**Sent:** 23/08/2021 10:10:25 AM  
**Subject:** Fwd: REV2021/0014 321-331 Condamine St Manly Vale  
**Attachments:** Planning Letter 1808 v3.pdf;

Dominic Leonard and Lauren Kelly  
8 Sunshine Street  
Manly Vale

The revised design for [REV2021/0014](#) has exacerbated the existing concerns for neighbouring residents. In particular, the revision of the landscaping plan.

View from Condamine st on right shoes how this 4 storey building will impose on 319 Condamine:

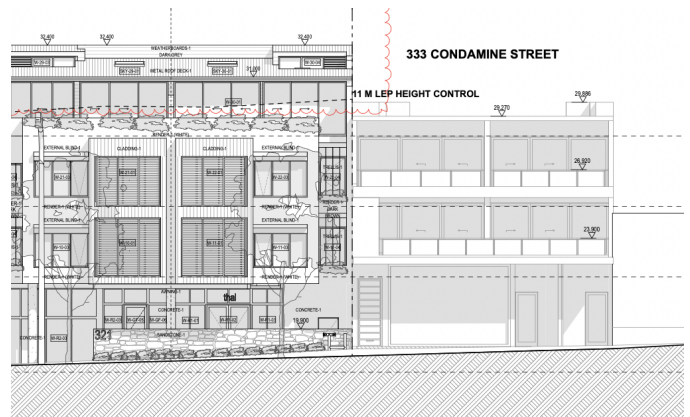
The development will sit adjacent to 319 Condamine St (undeveloped 2 storey) and 307-317 Condamine Street which uses step design to retain height compliance despite being '4' storeys. **For clarity the number of storeys above street level is a maximum of 3 as the street level rises to the west.** This proposal results in this imposing building along Sunshine Street and Condamine Street.
